FILE NUMBER: 20-DP-37

SUBJECT: Preliminary Site Plan review for an 18-unit residential development. (1105-1107 S 19 Ave).

APPLICANTS MUST ADDRESS ALL COMMENTS AND FINDINGS AS IDENTIFIED BY MEMBERS OF THE TECHNICAL ADVISORY COMMITTEE BOTH IN WRITING (IDENTIFY PAGE NUMBER OF THE CORRECTION) AND ON THE SITE PLAN (ALL CHANGES MUST BE IDENTIFIED, I.E. BUBBLED).

1 PROPOSED WEST ELEVATION
SCALE: 1/4"=1'-0"

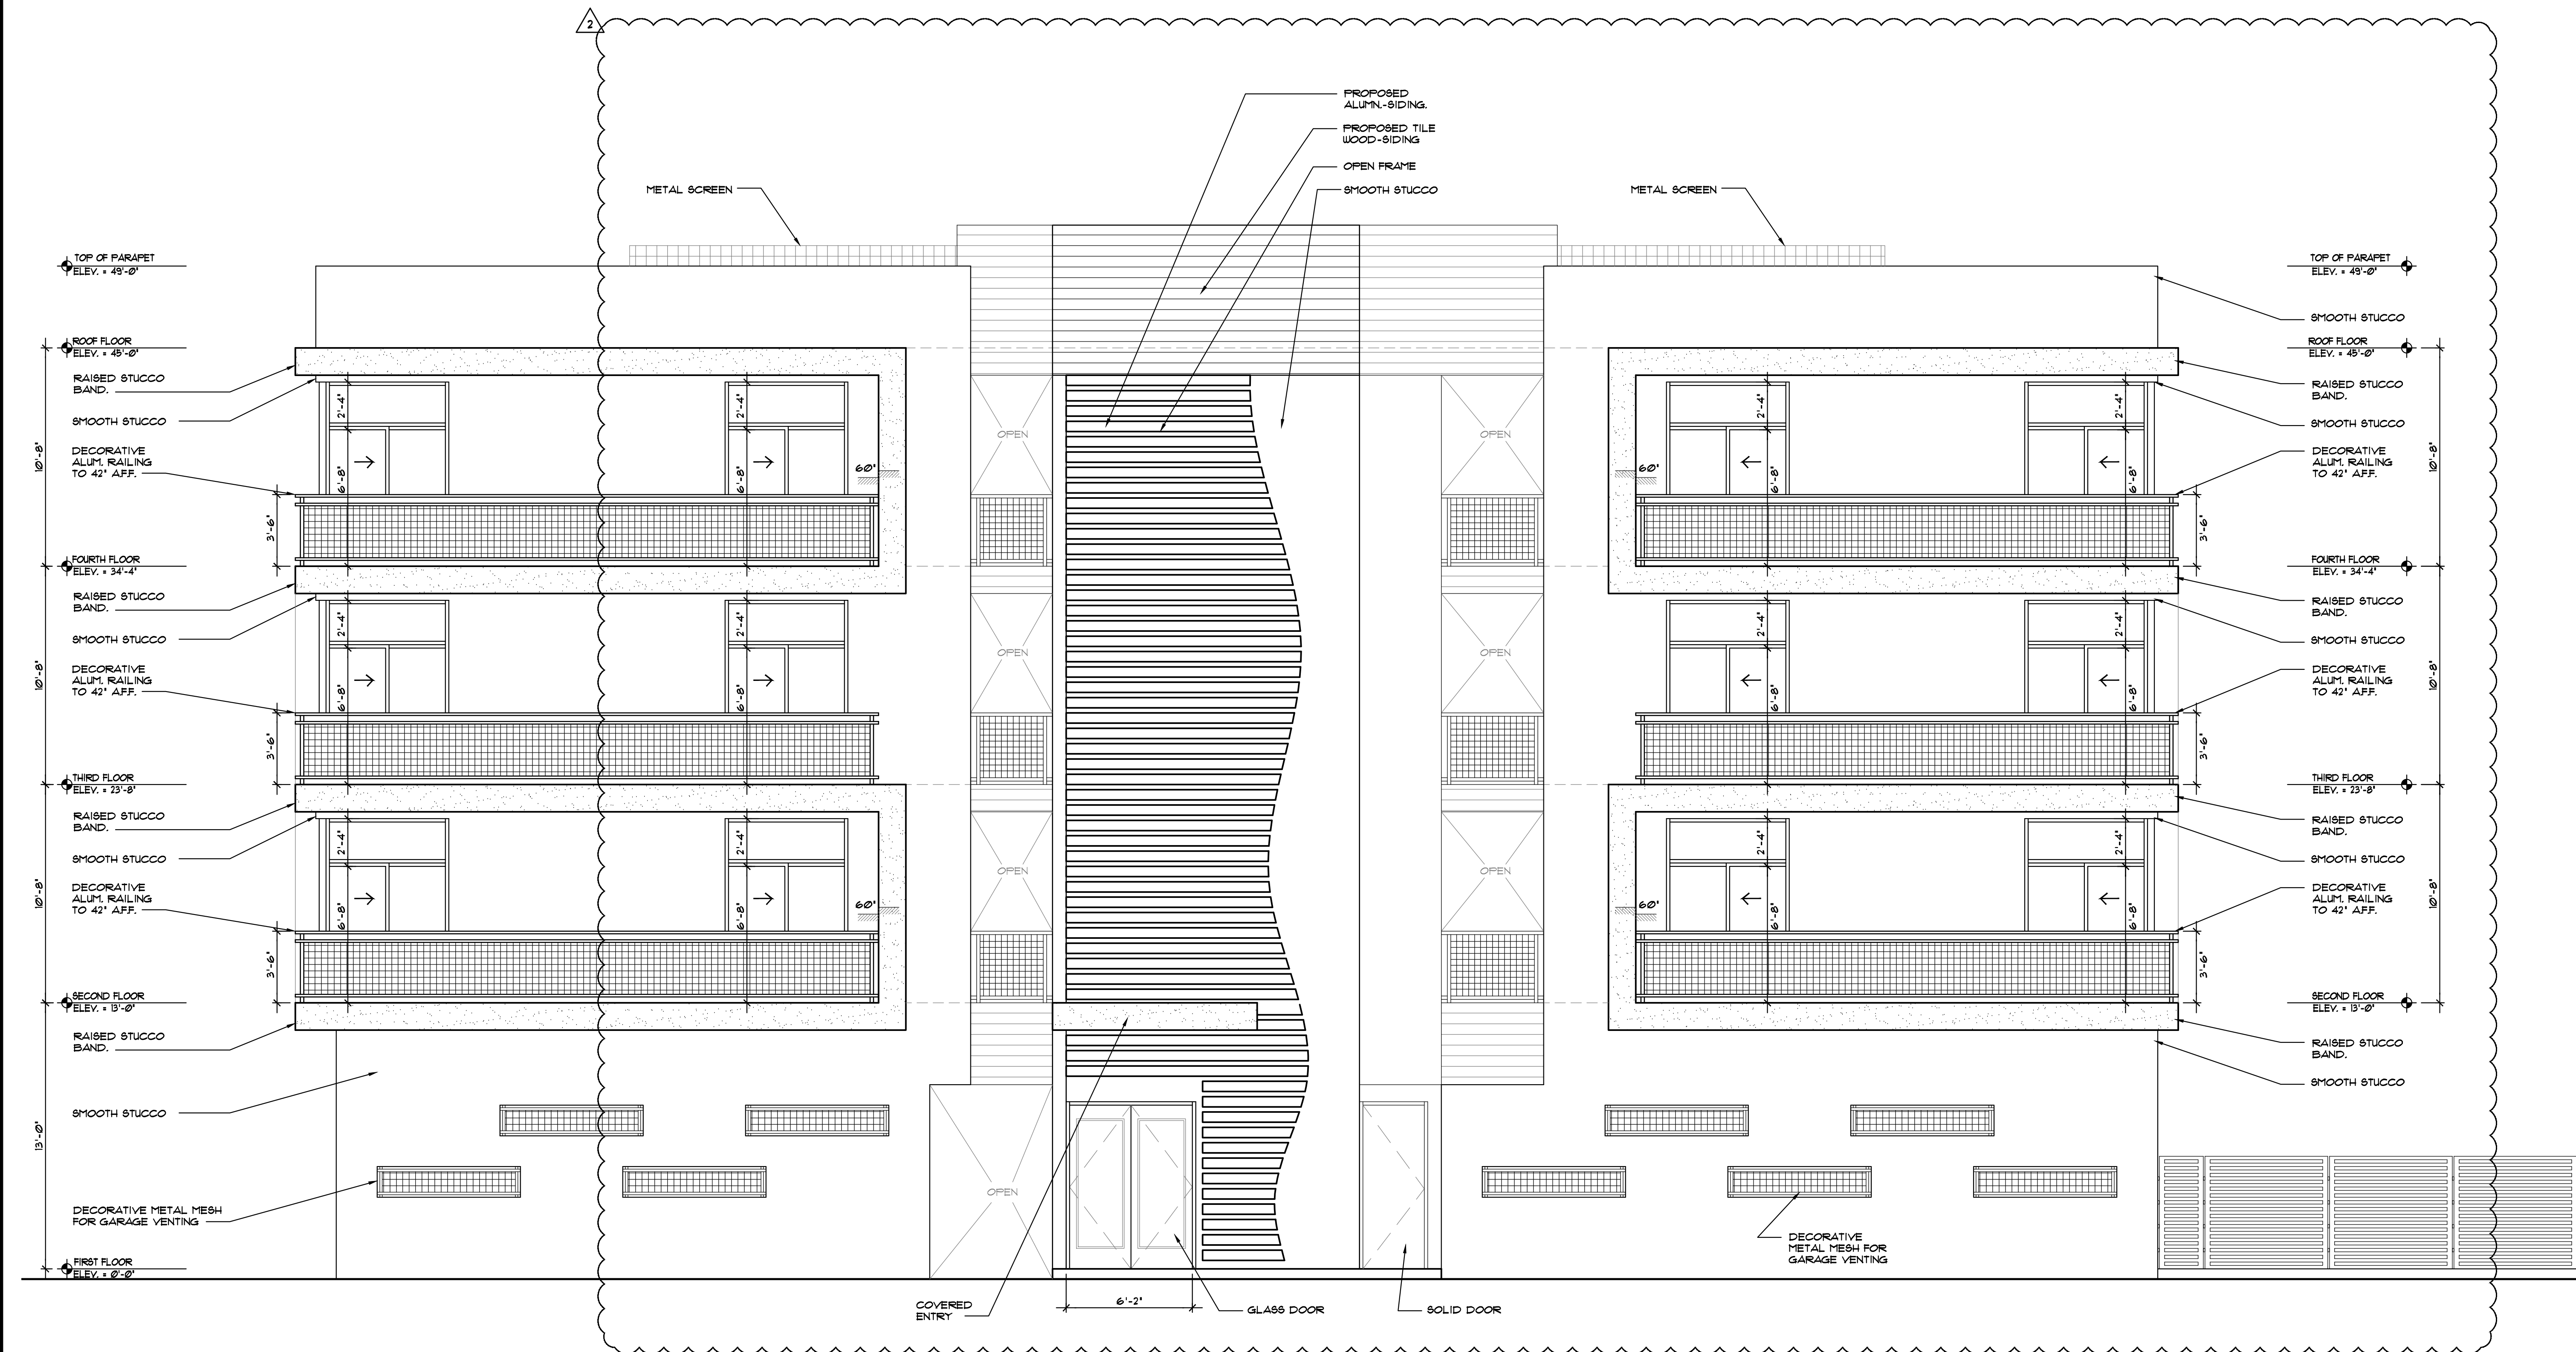
2. Provide additional articulation on north and south façade to impact the design from the public right of way. Provide balconies along these facades.

Response: Revised accordingly
